DELAWARE RIVER BASIN
GRASS LAKE CREEK, CARBON COUNTY
PENNSYLVANIA
NDS ID PA. 00615
DER ID 13-93

BIG BOULDER DAM

PHASE I INSPECTION REPORT NATIONAL DAM INSPECTION PROGRAM

PHASE I INSPECTION REPORT
NATIONAL DAM INSPECTION PROGRAM
BIG BOULDER DAM
NATIONAL ID #PA 00615
DER #13-93

FIELD OBSERVATION PLAN
BIG BOULDER DAM
DAM A
SHEET 5A OF 11

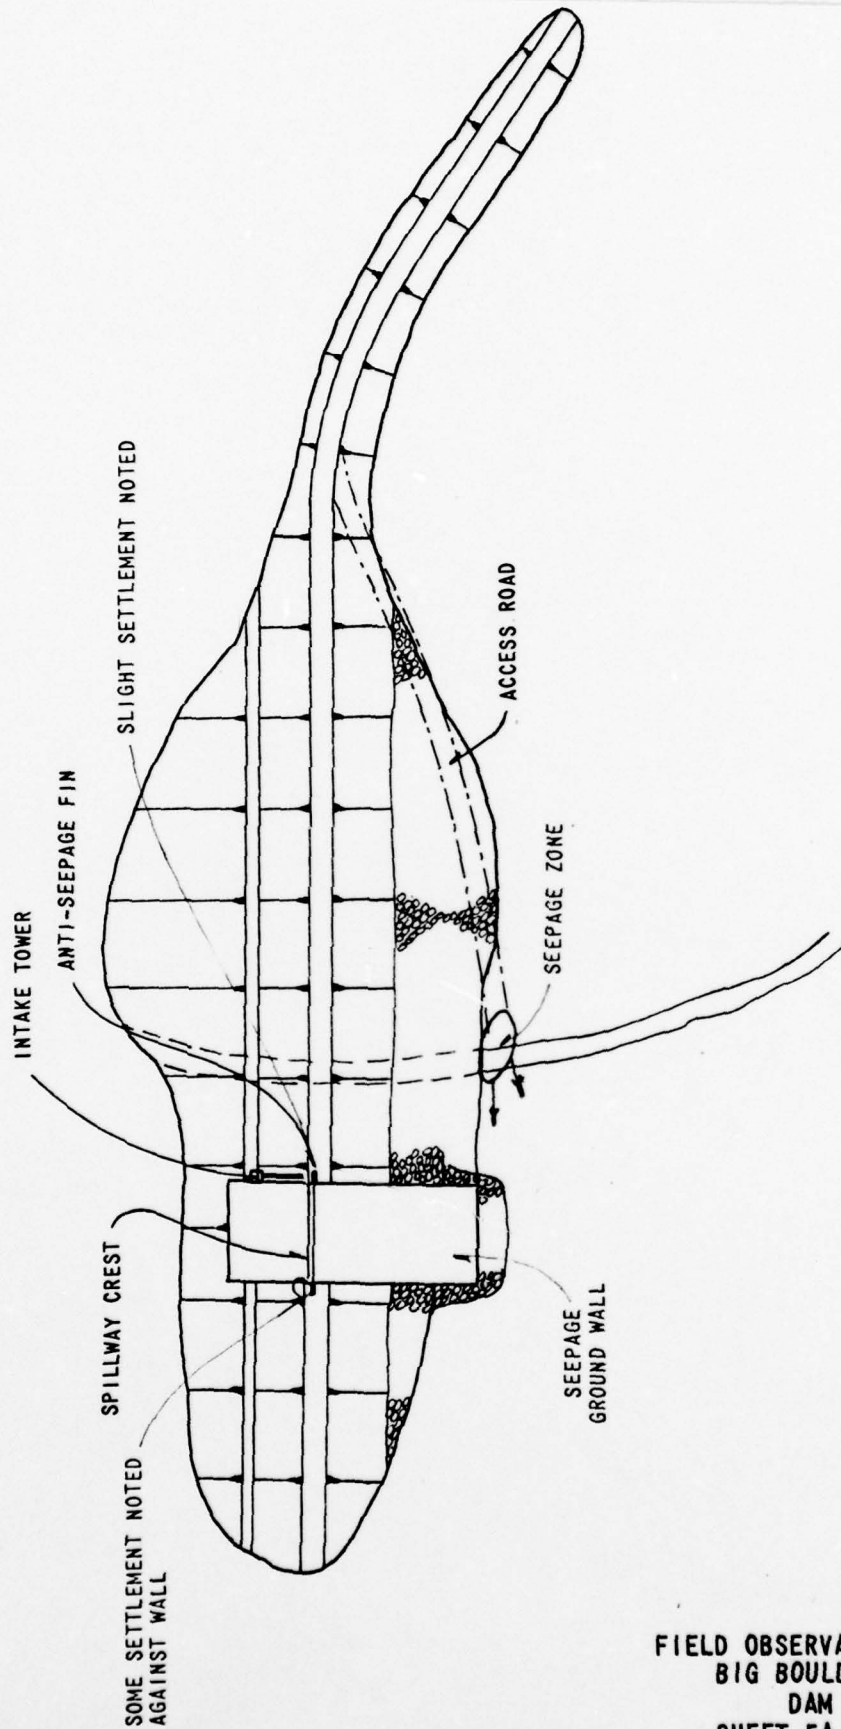
The downstream area of Dam B was also inspected and some small wet areas were noted, as shown on sheet 5a, Appendix B. However, based on discussions with the Owner's engineer, seepage rates are at least 90 percent less than rates prior to grouting. The engineer concluded this seepage is controlled sufficiently to insure stability of the embankment.

Yes. See Sheet 5a for the three locations of seepage observed.

PHOTOGRAPH NO. 8

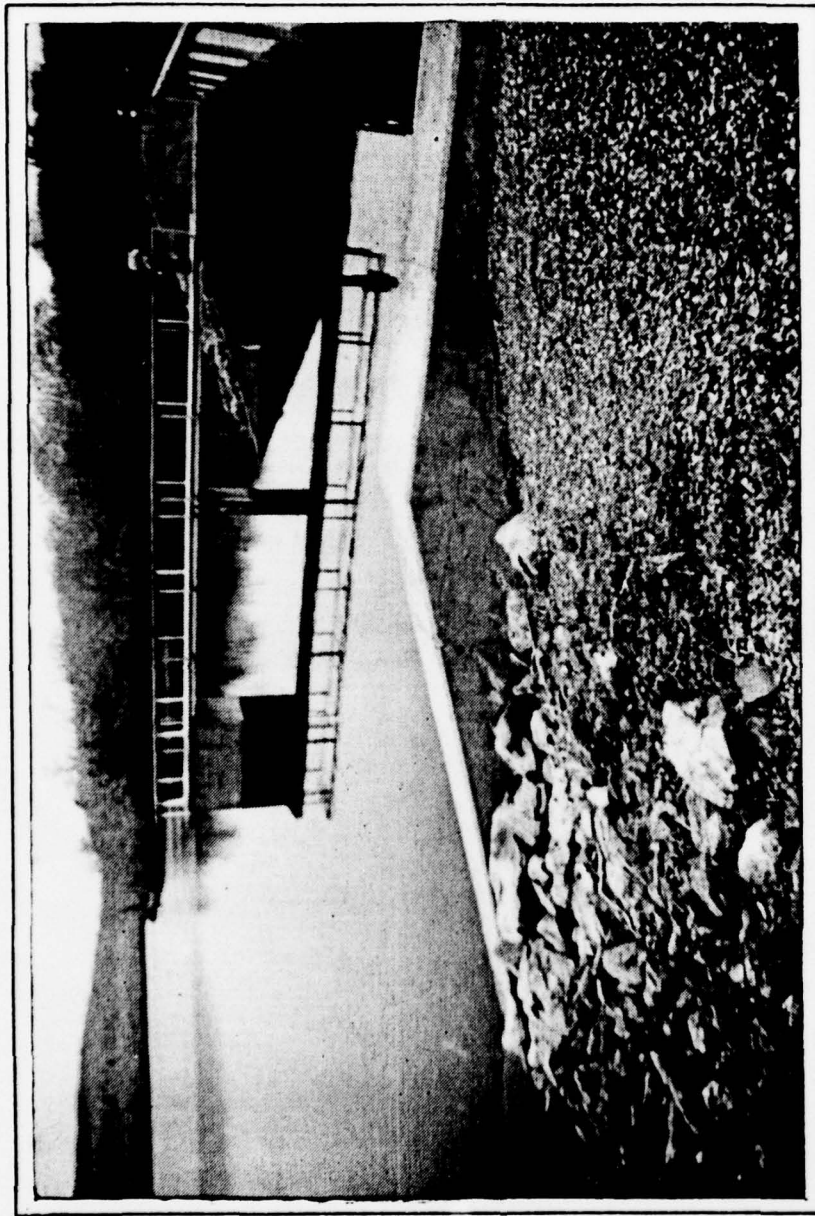
There are no indications of surface cracks noted on the embankment crest or slopes of Dams A and B. The asphalt roadway across Dam B is in good condition. As shown on Photograph 8, Embankment A has settled approximately four to six inches below the spillway anti-seepage walls. As shown on

TOP OF RIGHT RETAINING WALL OF SPILLWAY.
NOTE DIFFERENCE IN EMBANKMENT AND WALL
HEIGHT.

PLATE 5

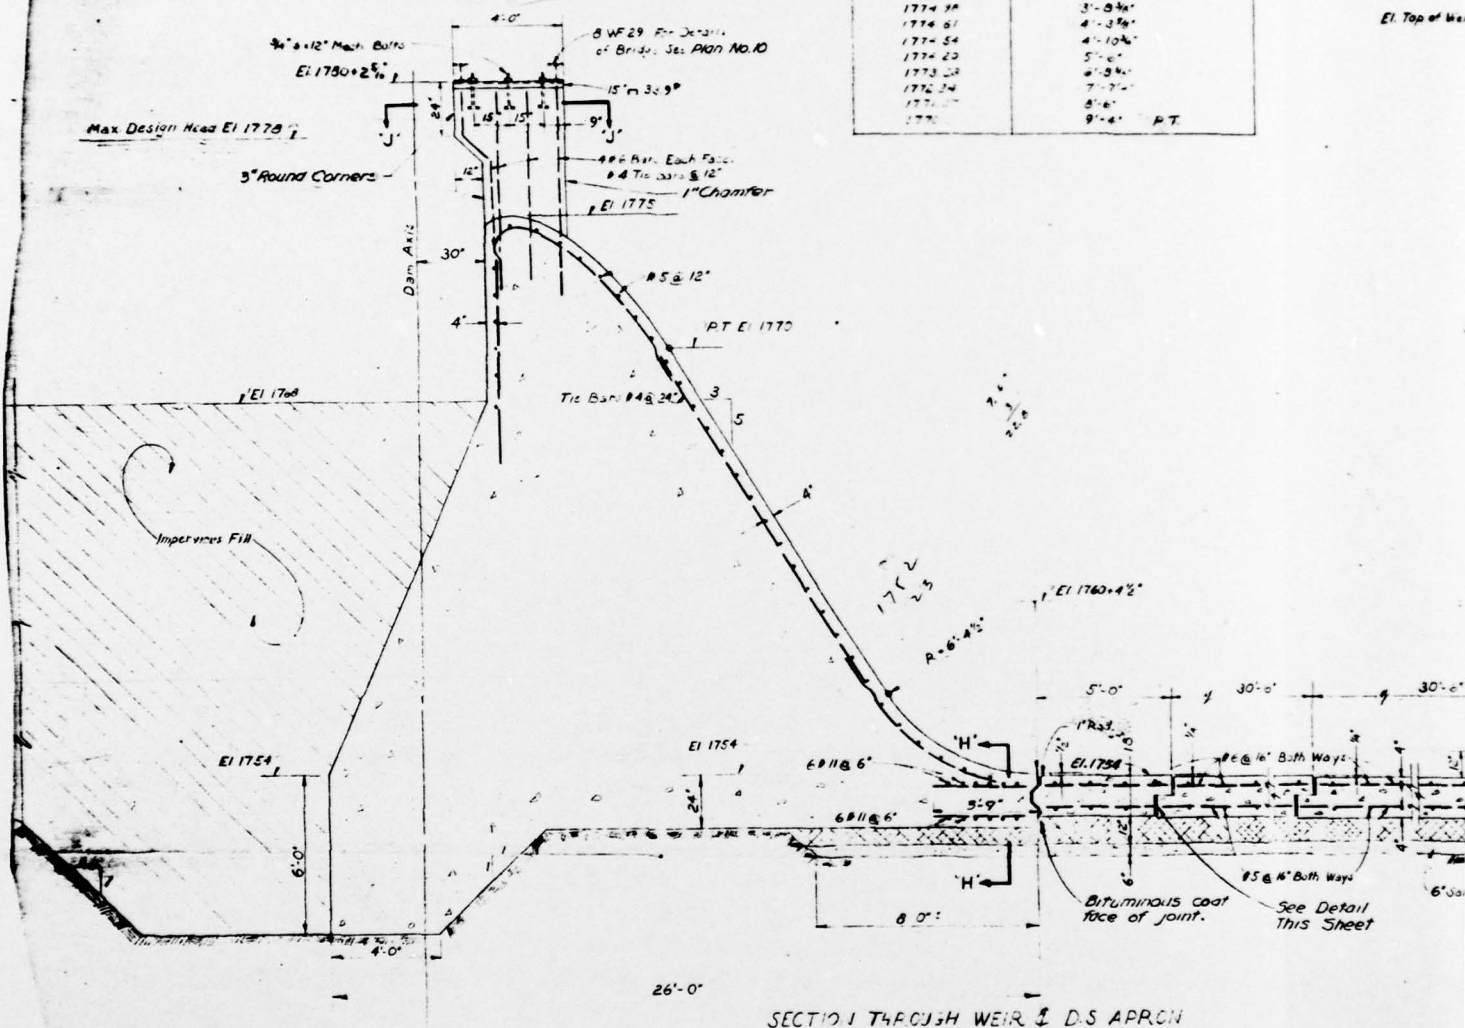
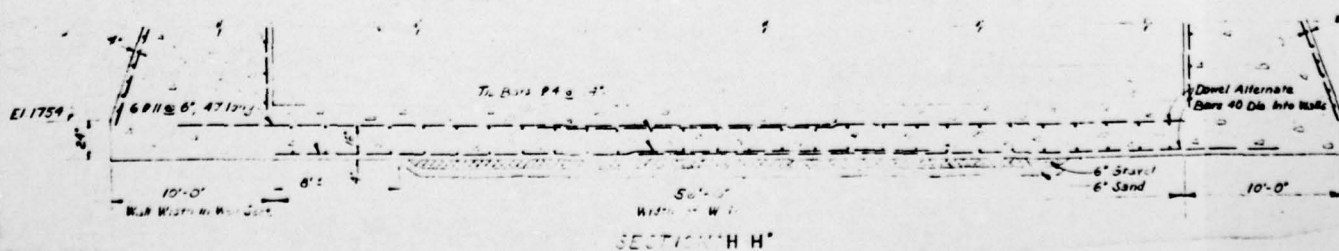
Plate 5, Section BB, the anti-seepage wing wall and the dam have the same design elevation.
